Entergy Nuclear Generation Co.
Pilgrim Nuclear Power Station
600 Rocky Hill Road
Plymouth, MA 02360

February 5, 2001
ENGCLtr. 2.01.004

Subject: Proposed Change to Pilgrim's Technical Specification Concerning the Safety Limit Minimum Critical Power Ratio

Figure 2 Reference Core Loading Pattern – Cycle 14

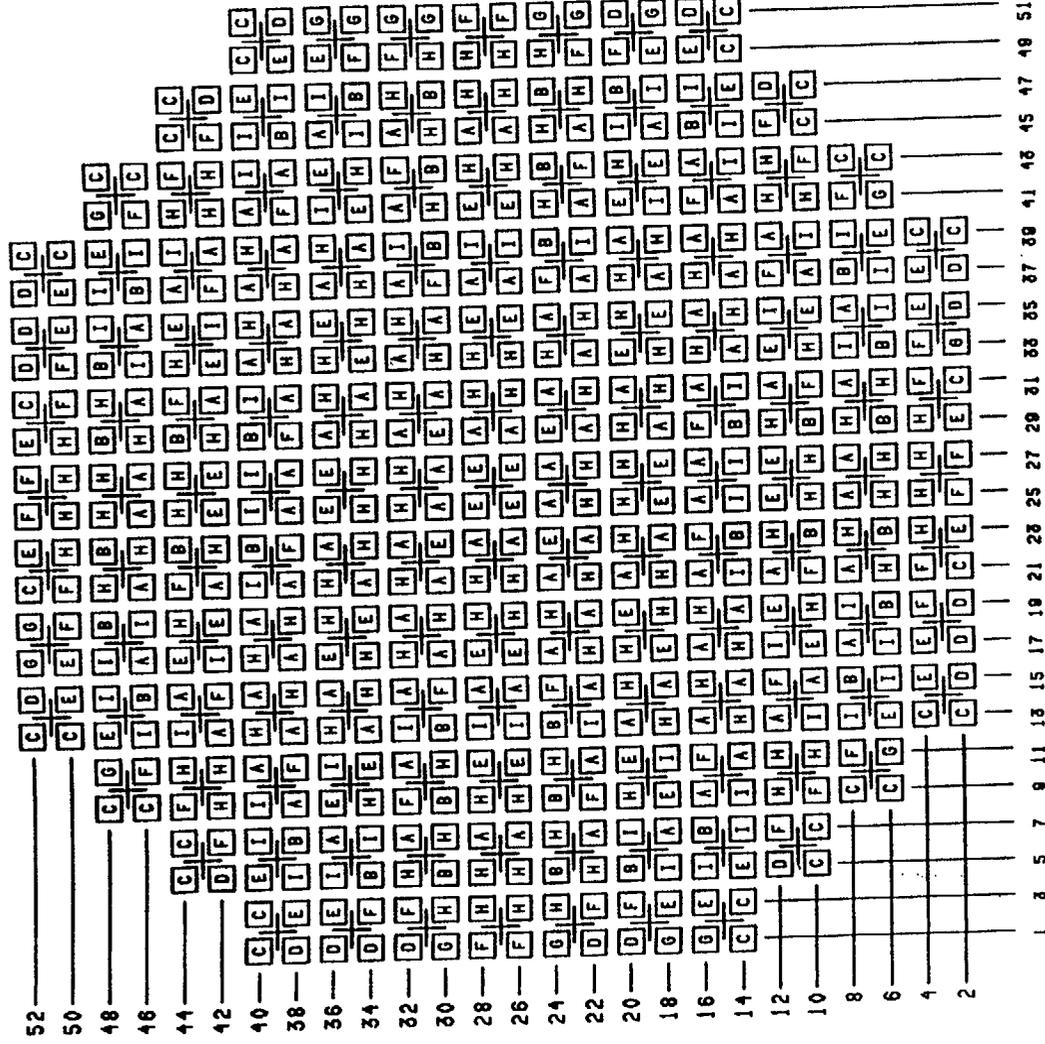
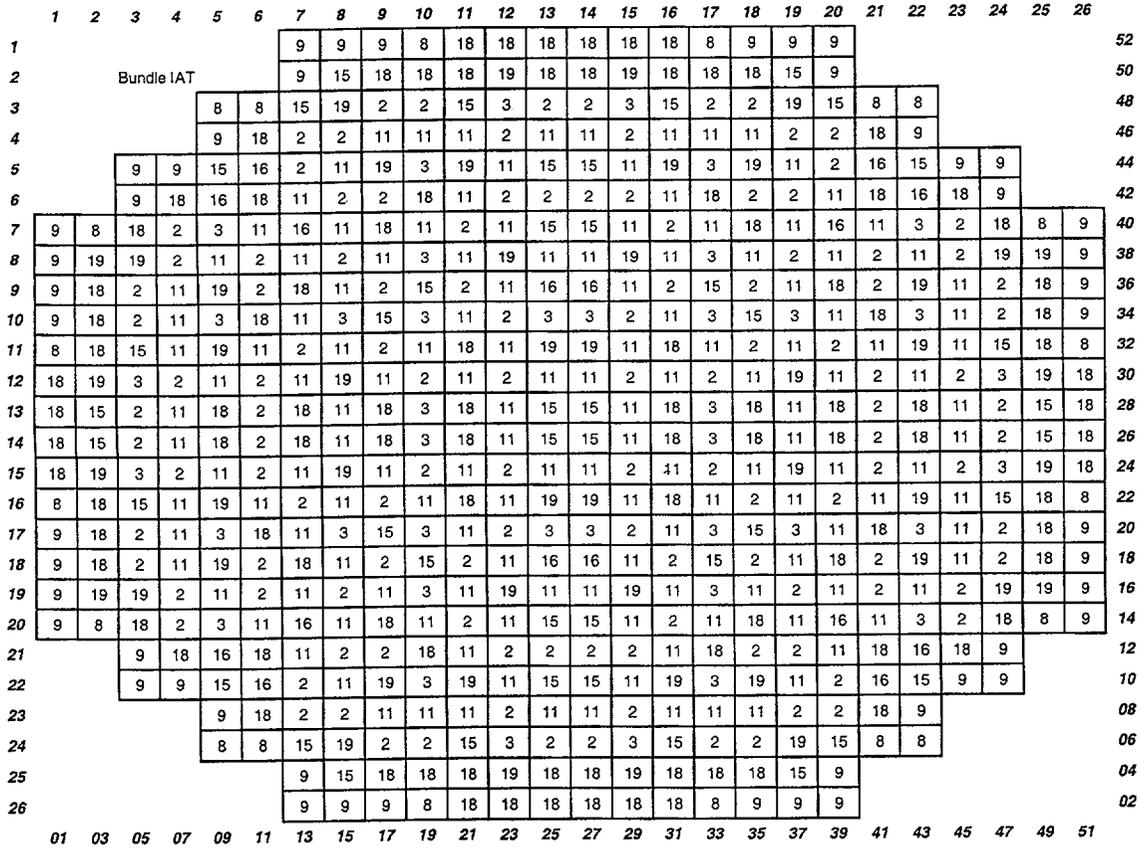
In comparing the Pilgrim Cycle 14 and 13 SLMCPR values it is important to note the impact of the differences in the core and bundle designs. These differences are summarized in Table 1. The Cycle 13 column and the GETAB power distribution uncertainty column for Cycle 14 are both provided for comparison to the Cycle 14 revised power distribution uncertainty column.

1. Provide the fuel types and numbers of assemblies used in Pilgrim Cycle 14 operation and identify if they are fresh or irradiated fuel (once or twice burned, etc.). Also, provide the fuel loading pattern for Cycle 14 and identify its difference from Cycle 13 and the impact on the SLMCPR calculation.
